Watts Bar Nuclear Plant, Unit 2  
NRC Docket No. 50-391

**Subject: Watts Bar Nuclear Plant (WBN) Unit 2 – Final Safety Analysis Report (FSAR) – Response to Requests for Additional Information**

This letter responds to requests for additional information (RAIs) regarding the Unit 2 FSAR concerning Auxiliary Feedwater.

## Condensate Storage Tank (CST)

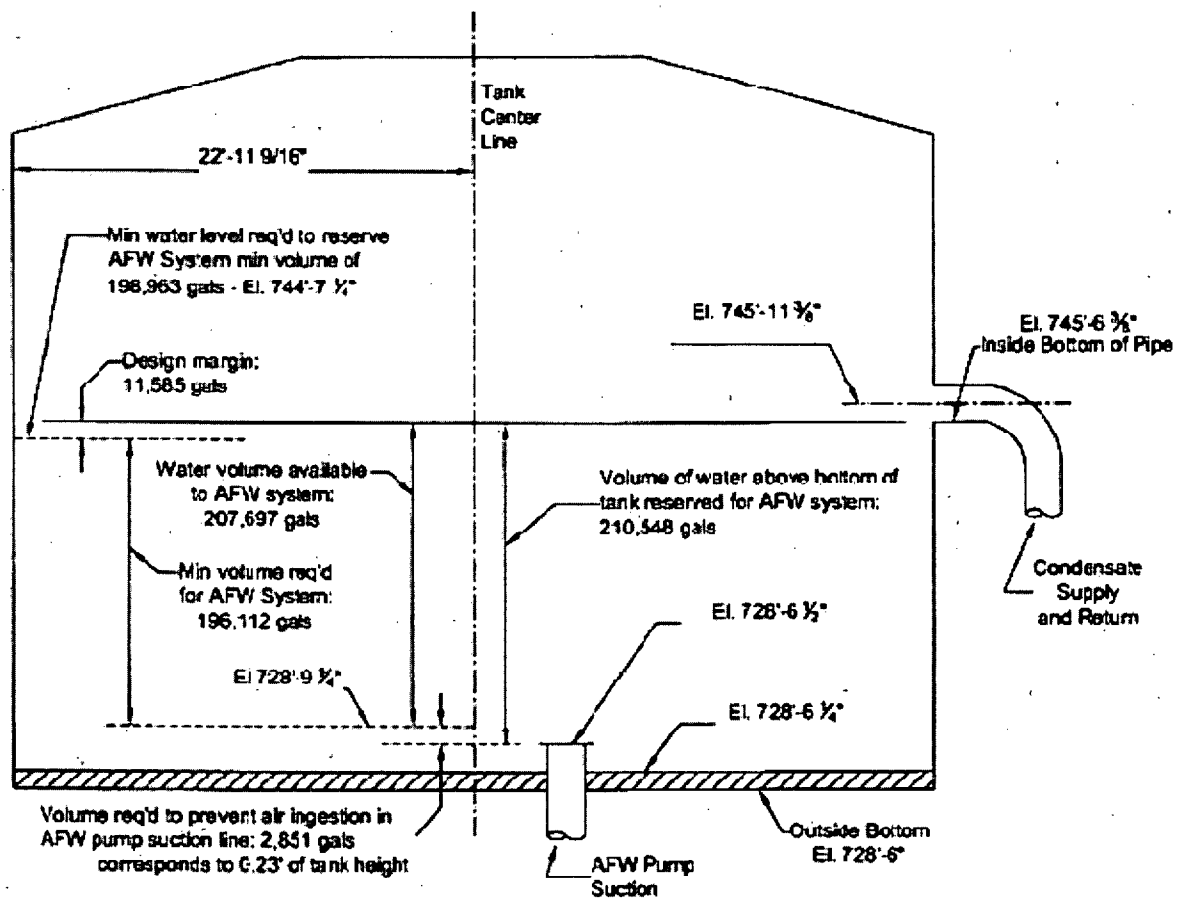
**AFW - 1** What is the basis for the value in the Tech Specs for CST level?

**Response:** Unit 2 Technical Specifications Limiting Condition for Operation (TS LCO) 3.7.6 states, "The CST level shall be  $\geq 200,000$  gal."

As described in the TS Bases for LCO 3.7.6, the CST level required is equivalent to a usable volume of  $\geq 200,000$  gallons, which is based on holding the unit in MODE 3 for 2 hours, followed by a cooldown to RHR entry conditions at  $50^{\circ}\text{F}/\text{hour}$ . This basis is established in the CST level calculation and exceeds the volume required by the accident analysis.

The quantity of feedwater required to bring the plant down to RHR cut-in conditions is 196,112 gallons, including a 3,000 gallon allowance to account for AFW Pump Heat described in Westinghouse Technical Bulletin TB-09-4, "Impact of Auxiliary Pump Heat on Westinghouse and Combustion Engineering Analyses / Methodologies."

There is 2,851 gallons of water unavailable due to vortexing / air injection, which results in a minimum required volume of CST water of 198,963 gallons. This is less than the TS requirement of  $\geq 200,000$  gallons.

See Figure on next page.
